Subject: Transmittal of Revision 1 to Service Bulletin Number
V2500-ENG-72-0132

International Aero Engines SERVICE BULLETIN

ENGINE - LP COMPRESSOR - REMOVAL OF
STAGE 6 BUFFER AIR SYSTEM

V2500 - ENG - 72 - 0132

Location of the LT Harness
Figure 10 (Sheet 1)

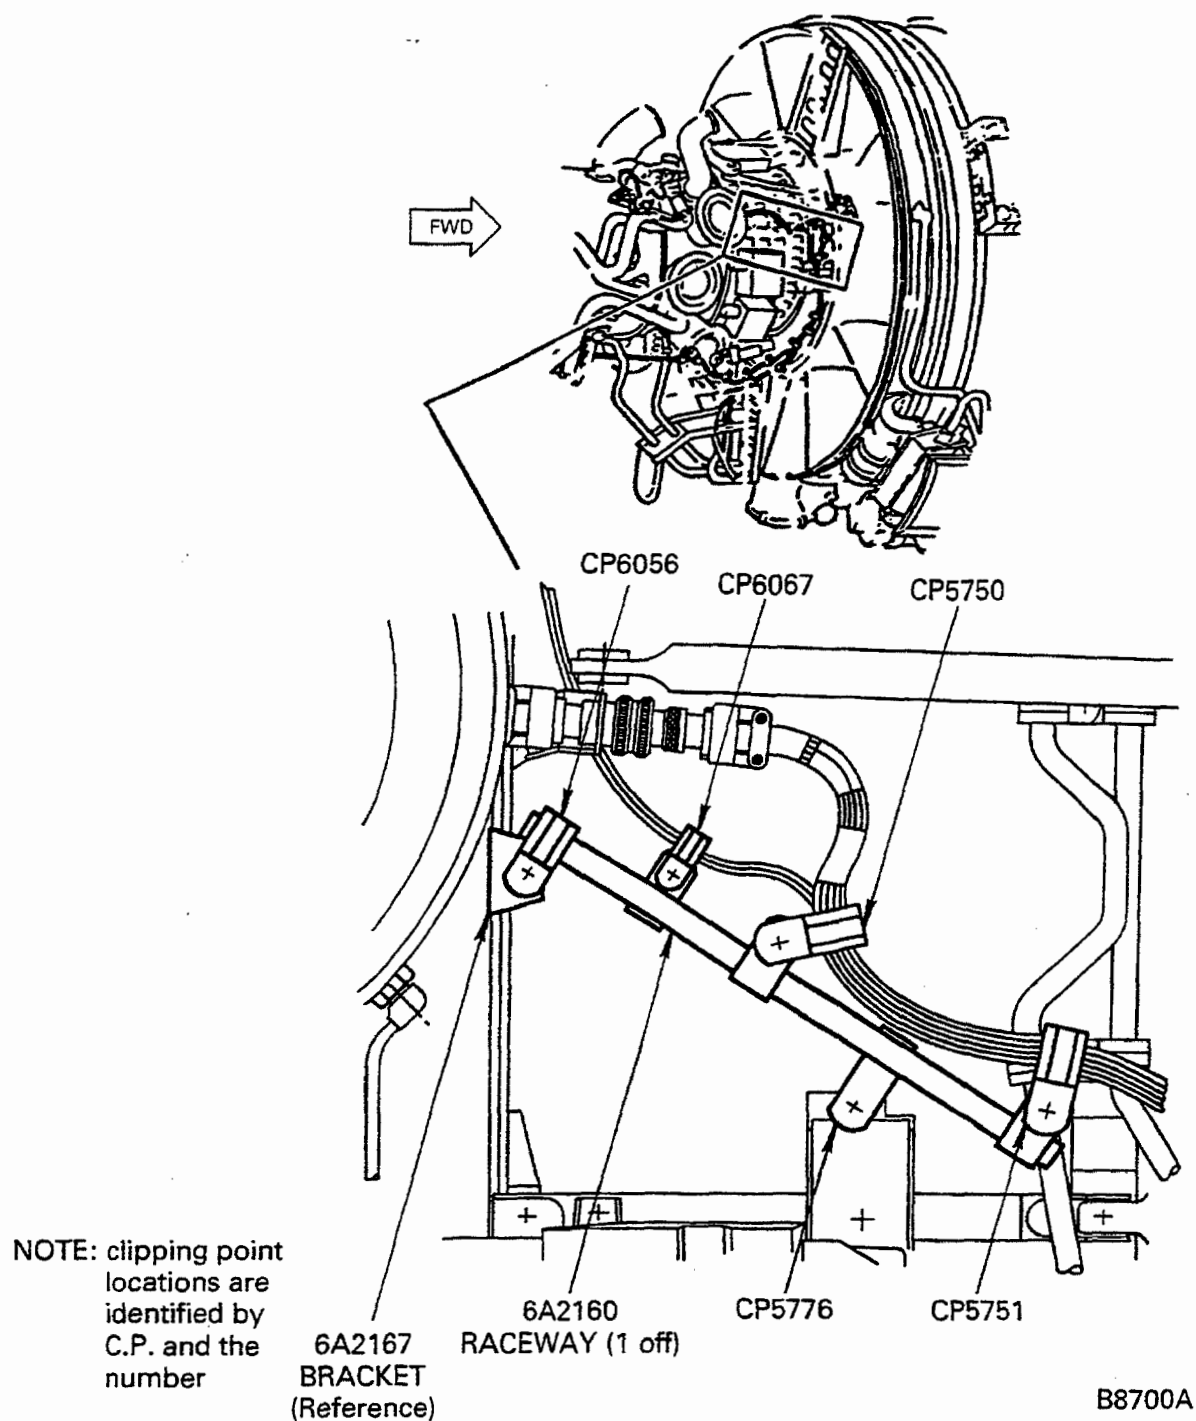
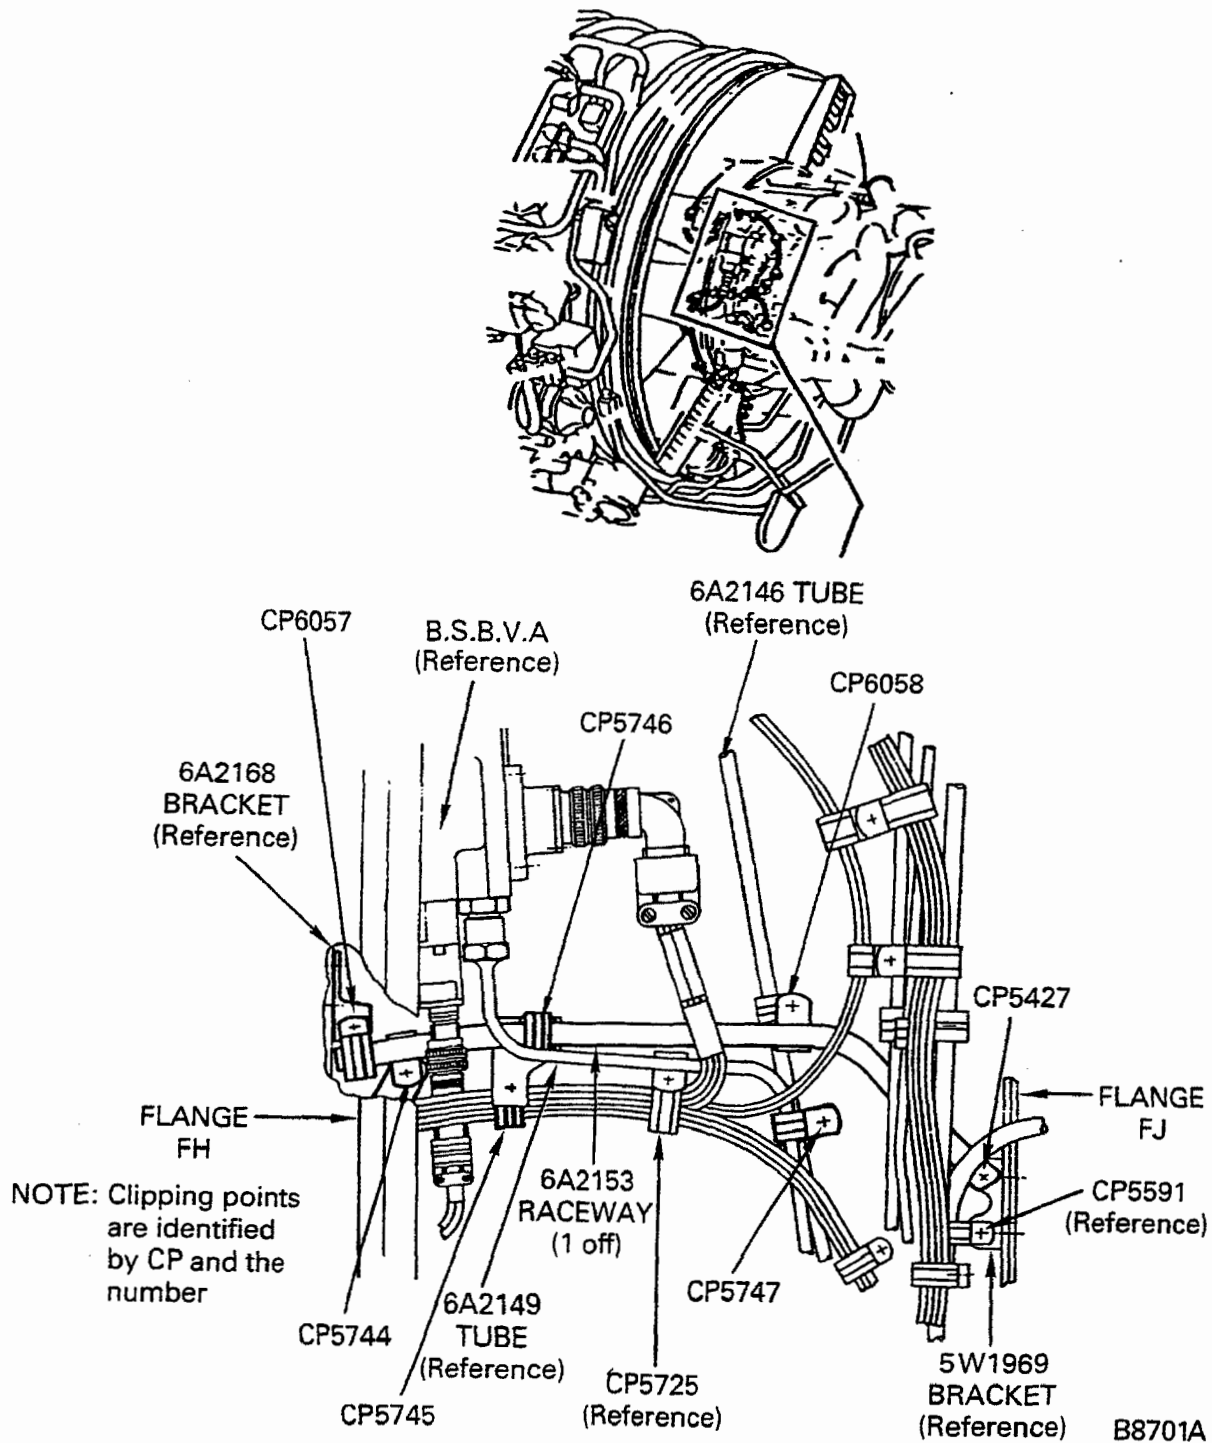
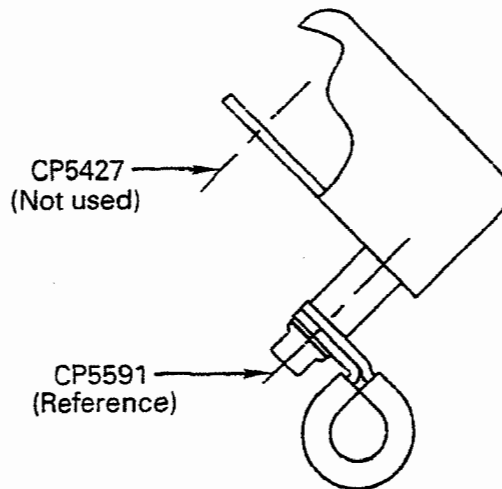
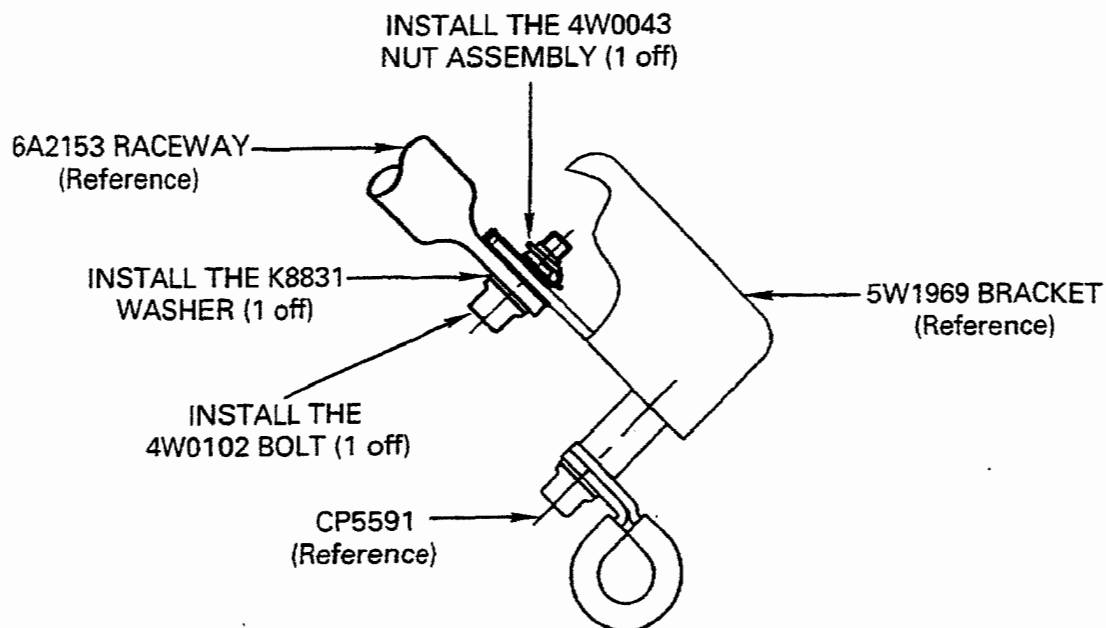
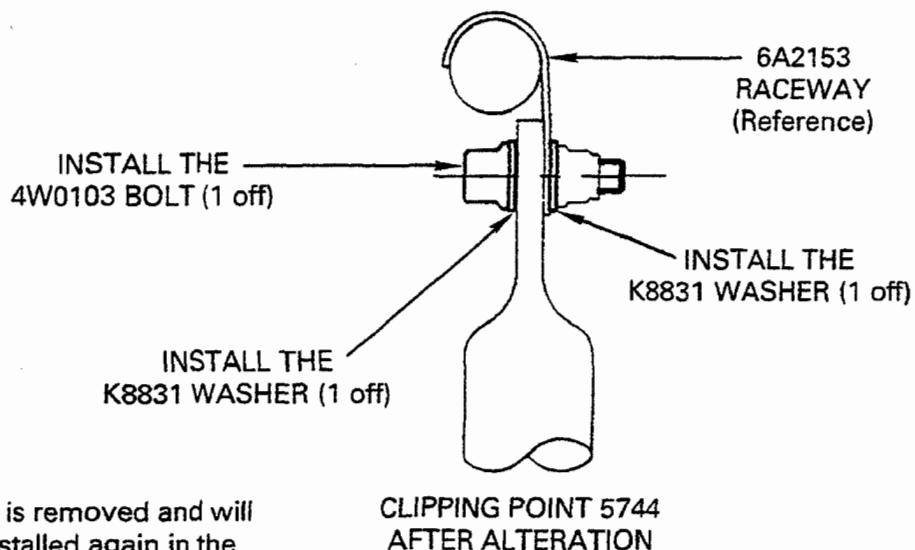
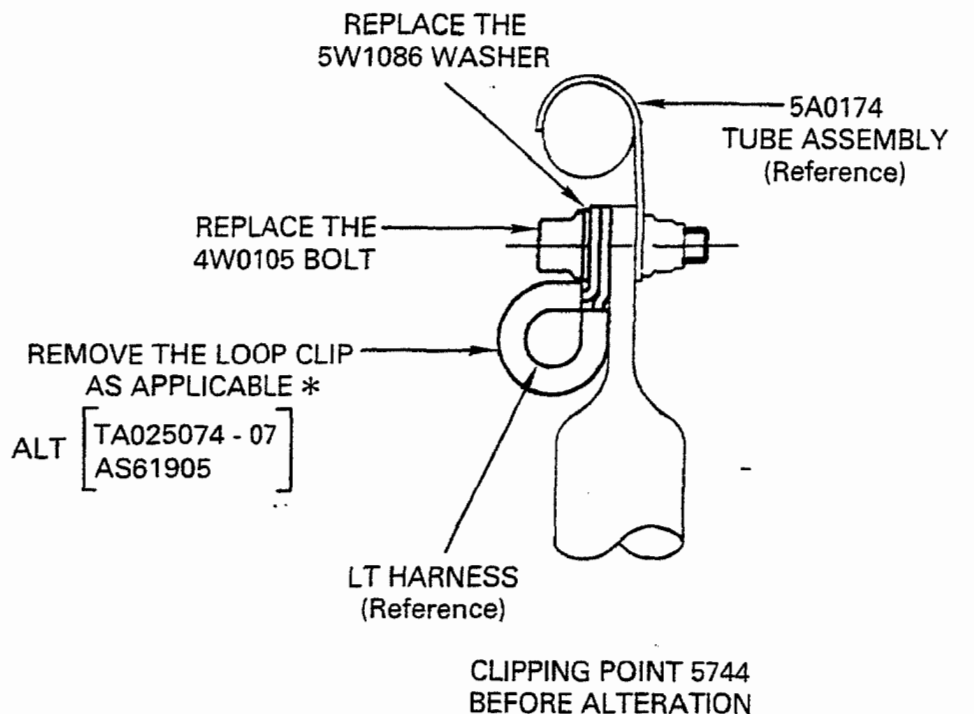
- (8) When you do the procedure given in Reference (3), Chapter/Section 72-00-40, Installation-09 install the parts which follow:
- (a) Install the 4W0102 Bolt (1 off) and the K8831 Washers (2 off) at clip position 5747. See Figure 10.

- (h) When you install the Electronic Engine Control Core Harness, install the parts which follow, at the specified locations:
 - 1 Install the 4W0103 Bolt (1 off) and the K8831 Washers (2 off) at clip position 5750. See Figure 10.
NOTE: The 5W1031 Sleeve Spacer is removed from this location.

- 2 Install the 4W0102 Bolt (1 off) and the K8831 Washers (2 off) at clip position 5751. See Figure 10.
NOTE: The 5W1031 Sleeve Spacer is removed from this location.

- 3 Install the 4W0103 Bolt (1 off) and the K8831 Washer (1 off) at clip position 5744. See Figure 10.
NOTE: The TA025074-07 Clamp (1 off) or the AS61905 Clamp (1 off) is removed from this location.

- 4 Install the 4W0102 Bolt (1 off) and the K8831 Washer (1 off) at clip position 5745. See Figure 10.
- (i) Install the 6A2153 Raceway at clipping points 5427 and 6057. Use the 400WSS8 Clip (1 off), 4W0043 Nuts (2 off) one at each location, K8831 Washers (2 off) one at each location, and 4W0102 (2 off) one at each location. See Figure 10.

- (j) Install the 4W0105 Bolt (1 off), K8831 Washers (2 off), UP10478 Spacer (1 off) 400WSS6 Clip (1 off) and 4W0001 Nut (1 off) at clip position 6058. See Figure 10.

- (k) Install the AS21400 Bolt (1 off), K8831 Washers (2 off), AS62503 Clip (1 off) and the AS20624 Nut (1 off) at clip position 6067. See Figure 10.
- (l) Install the 400WSS8 Clip (1 off) and K8831 Washer (1 off) at clip position 5746. See Figure 10.

- (m) Install the 6A2160 Raceway at clipping points 5776 and 6056 using the 400WSS8 Clip (1 off), 4W0043 Nuts (2 off) one at each location, K8831 Washers (2 off) one at each location, 4W0102 Bolts (2 off) one at each location. See Figure 10.

Location of the Bracket (6A2168)
Figure 11

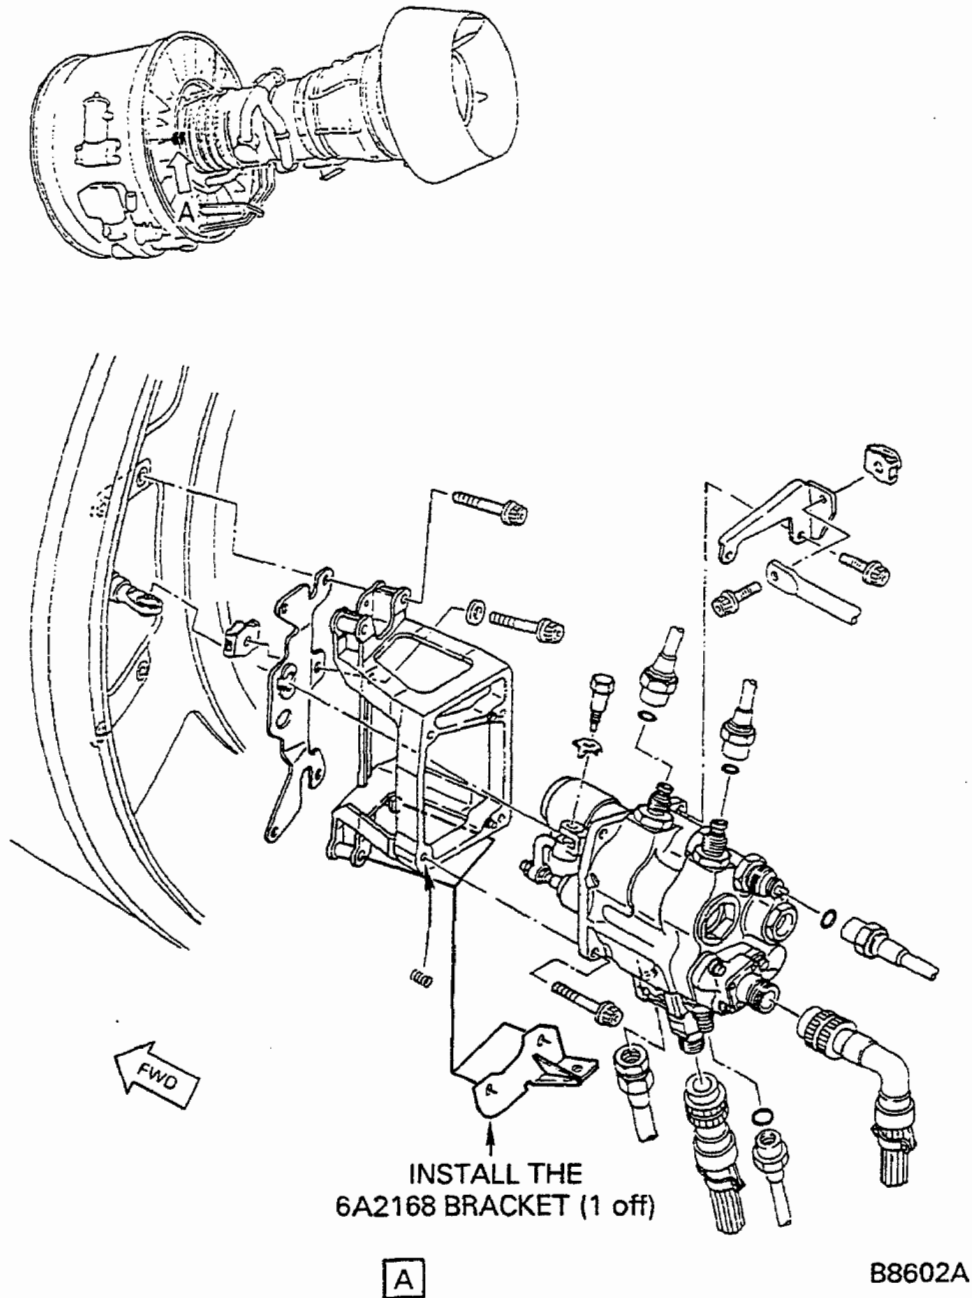
- (b) Install the 6A2168 Bracket (1 off). See Figure 11.
- (c) Do not install the parts listed below. These parts will not be used with the new configuration. See Figure 12 for part locations. The parts are:

Location of the FBC Buffer Air Tube Assemblies
and Related Hardware
Figure 12 (Sheet 1 of 2)

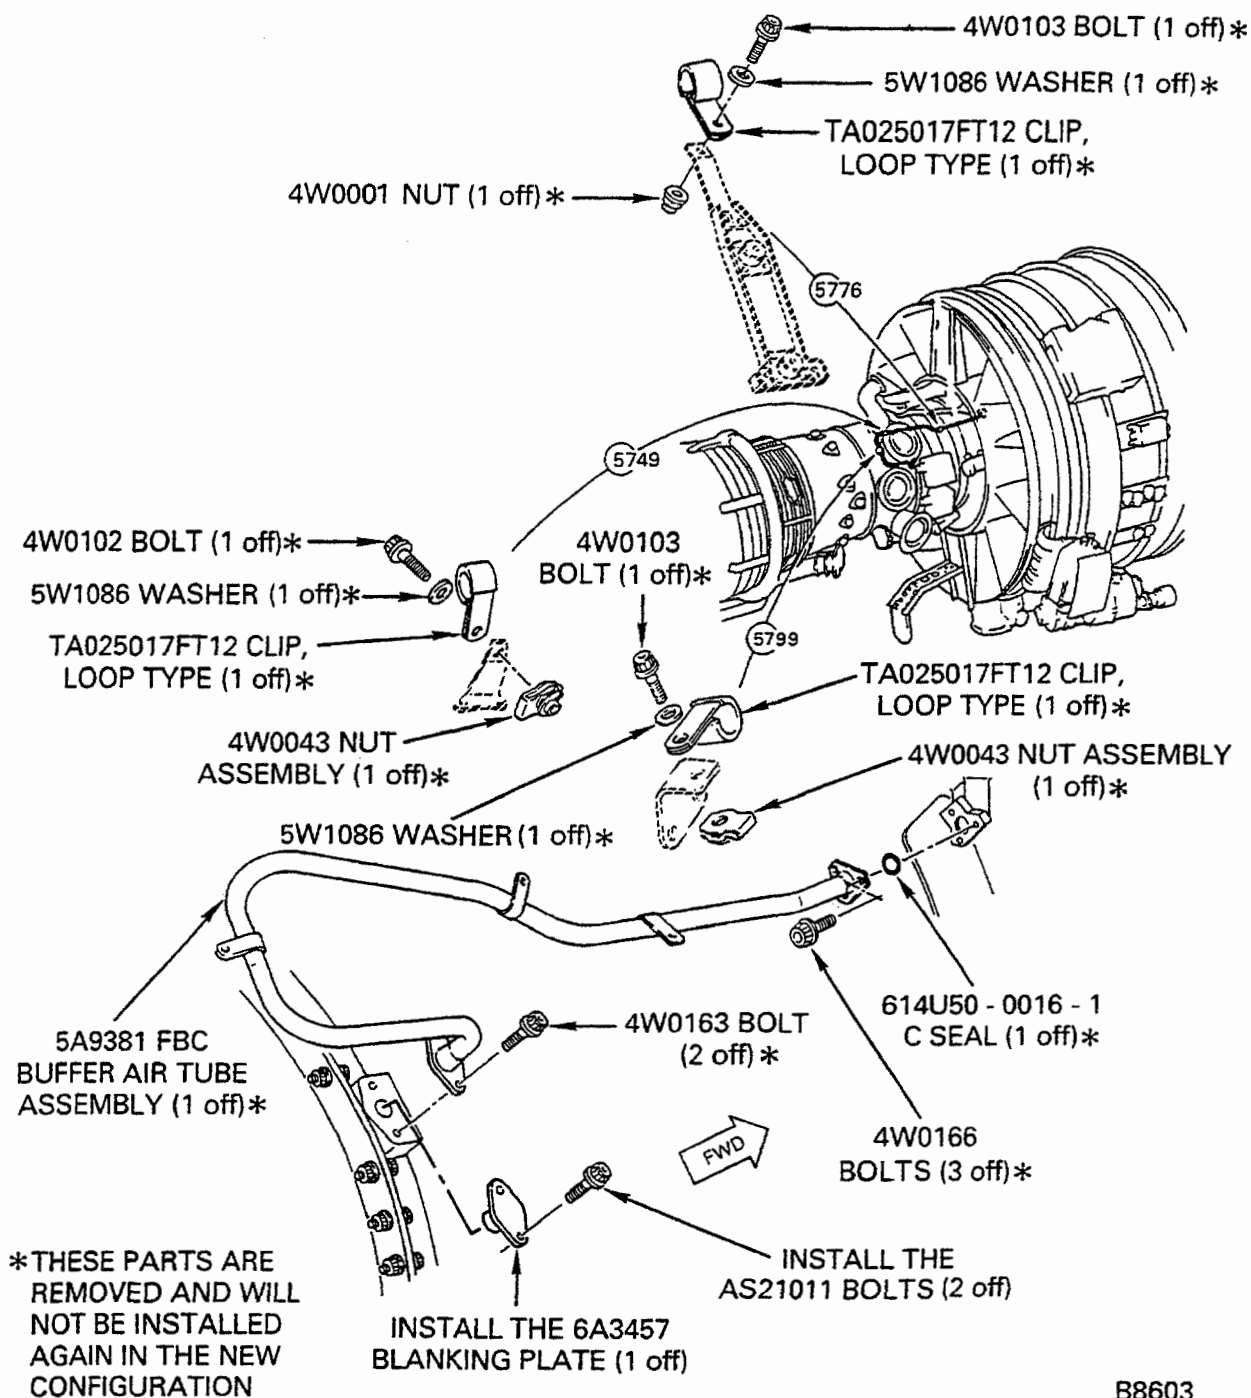
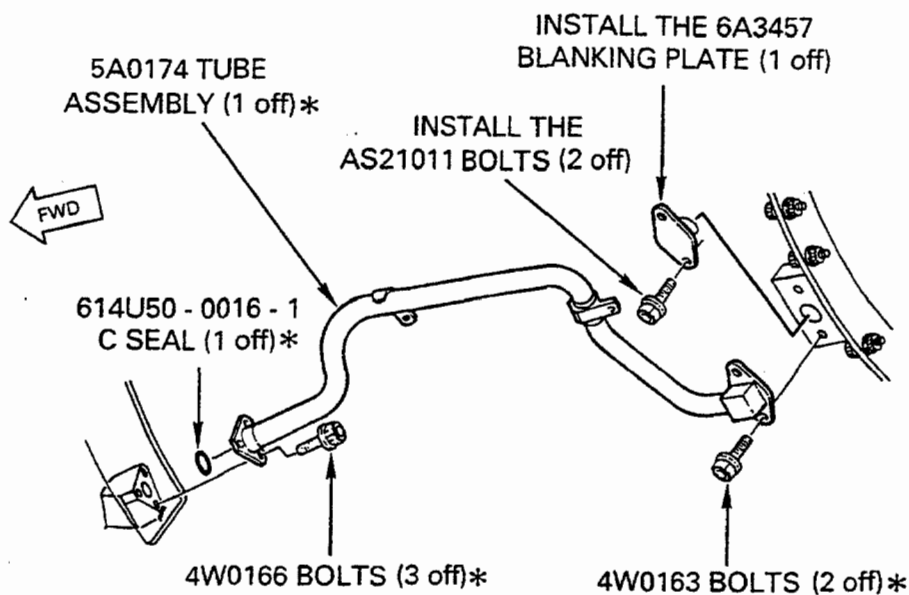
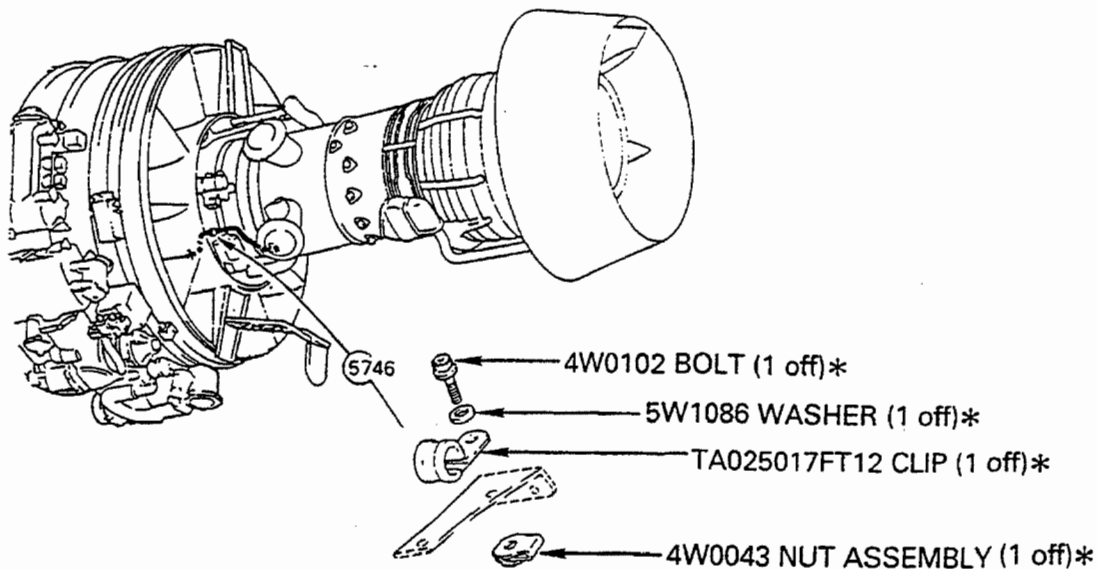
- 1 the 5A9381 FBC Buffer Air Tube Assembly (1 off),
- 2 the 4W0163 Bolts (4 off), 2 each, at two locations,
- 3 the 4W0166 Bolts (6 off), 3 each, at two locations,

- 4 the 4W0102 Bolt (2 off), 1 each, at two locations,
- 5 the 5W1086 Washers (4 off), 1 each, at 4 locations,
- 6 the TA025017FT12 Clips (4 off), 1 each, at 4 locations,

- 7 the 4W0043 Nut Assembly, 1 each, at 3 locations,
- 8 the 4W0103 Bolt (2 off) 1 each, at 2 locations,
- 9 the 4W0001 Nut (1 off),
- 10 the 614U50-0016-1 C Seal (1 off),

- 11 and the 5A0174 Tube Assembly (1 off)
- (d) Install the 614U50-0016-1 C Seals (2 off) and the 6A3457 Blanking Plates (2 off), one of each part at the locations given in Figure 12.

- (f) Install the Bolts, two at each location given in Figure 12, and tighten them with your hand.
- (g) Torque the Bolts to 75 to 85 lbfin (8,47 to 9,64 Nm.) Refer to Refer to Reference (4), Chapter/Section 70-41-00 Torque Tightening Technique.
